Comment Letter HH

RE: WIND ENERGY ZONING ORDINANCE AND GENERAL PLAN AMENDMENT
 ENVIRONMENTAL IMPACT REPORT; POD10-007, LOG NO. 09-00-003; SCH NO.
 2010091030

Response to Comment Letter HH

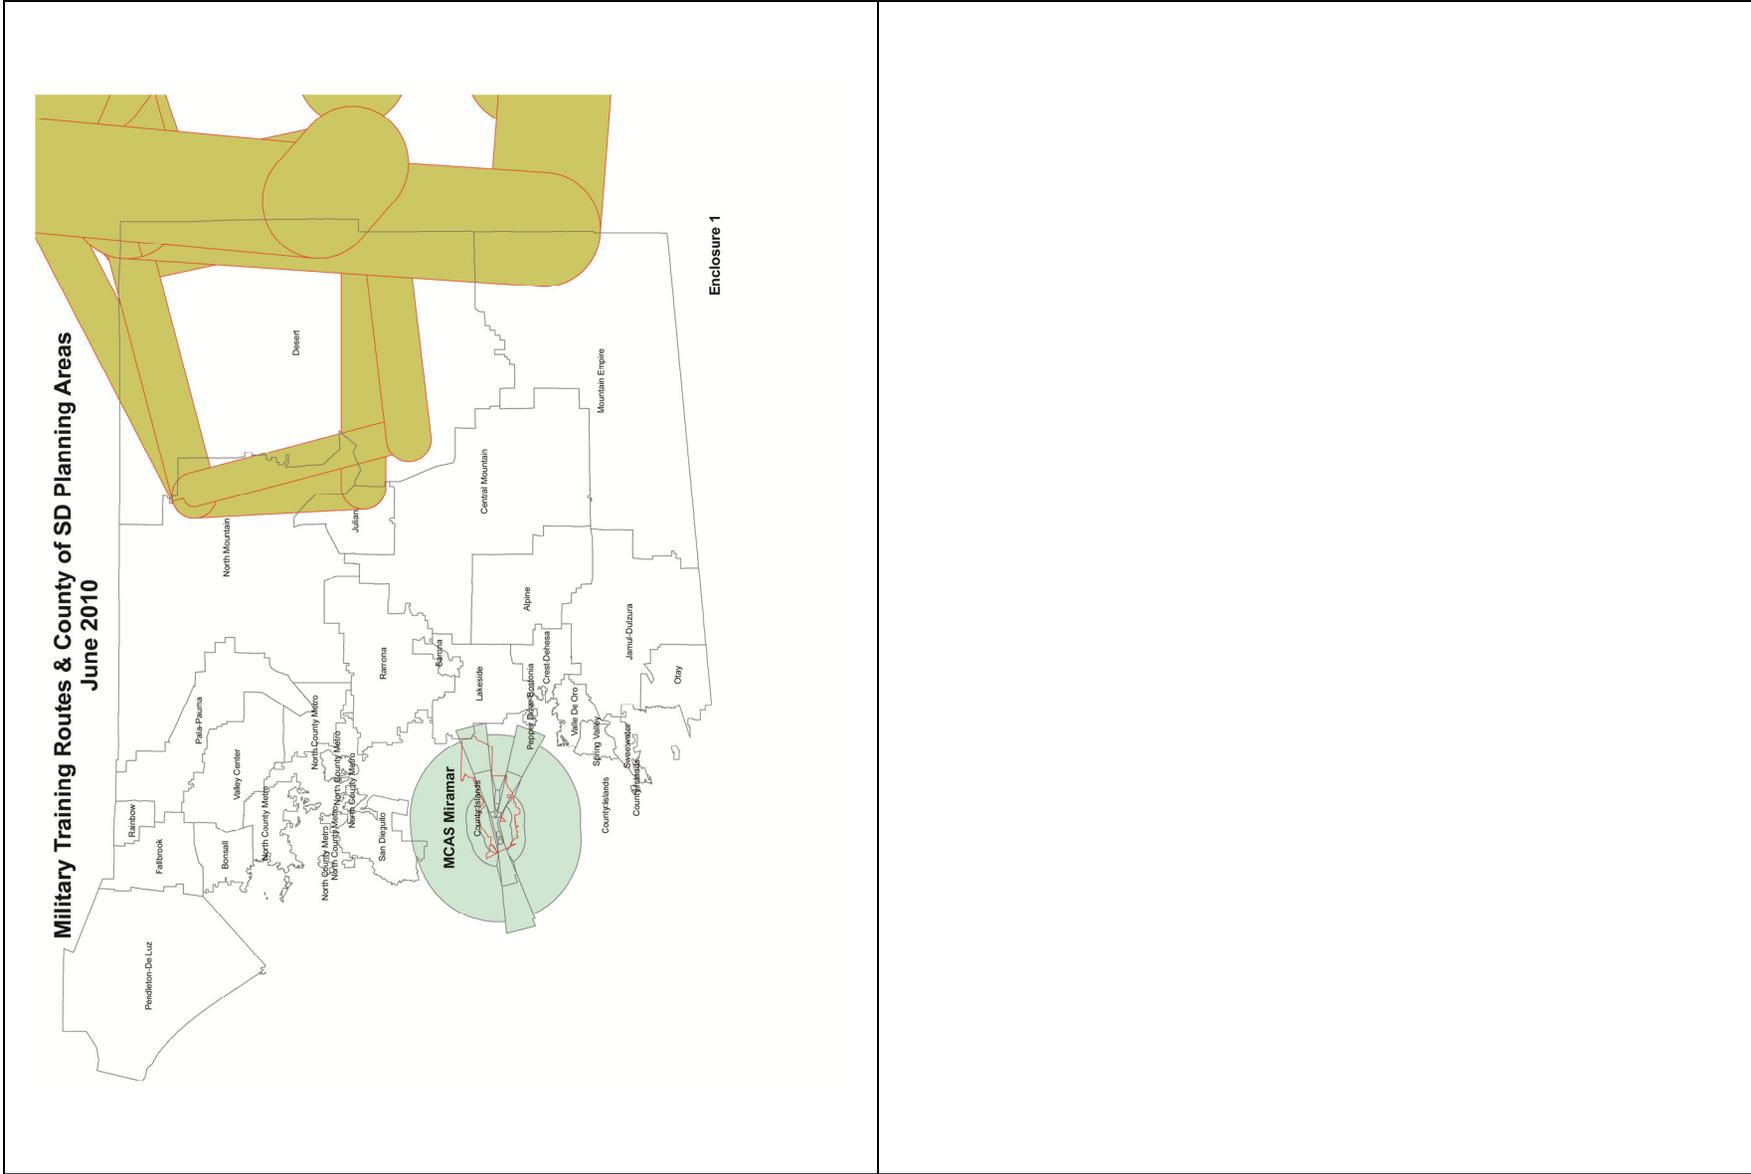
After reviewing the document, our primary concern deals with the construction of large and small wind turbines under or in the vicinity of a Military Training Route (MTR). Wind turbines are a physical obstruction that can be a source of radar interference for military aircraft. Additionally, while located many miles away from a military installation, these structures can restrict low-level aircraft flights and in turn jeopardize the purpose of military installations and the integrity of the airspace. To ensure that military operations are not restricted in East San Diego County, we recommend that language be included in the revised ordinance that states that the military should be consulted when single and/or multiple large or small wind turbines are proposed for construction under any MTRs. This will ensure safety of flight for military aircraft, and allow the County of San Diego and project proponent to receive feedback directly from a prominent aviation user of airspace in that region. To assist with our recommendation, we have included a map showing MTRs in San Diego County (Enclosure (1)).

HH-2 The County acknowledges and appreciates this comment. In response to this comment, the proposed ordinance has been revised to include a provision that will require notification to the military when small turbines are proposed in Military Training Routes. Administrative processing procedures are already in place to ensure the military is consulted on all large turbine projects during the discretionary review process. Finally, the County has coordinated with David Hulse, Community Plans and Liaison officer, NAVFAC Southwest to ensure the County's GIS Database includes all relevant Military Training Route data.
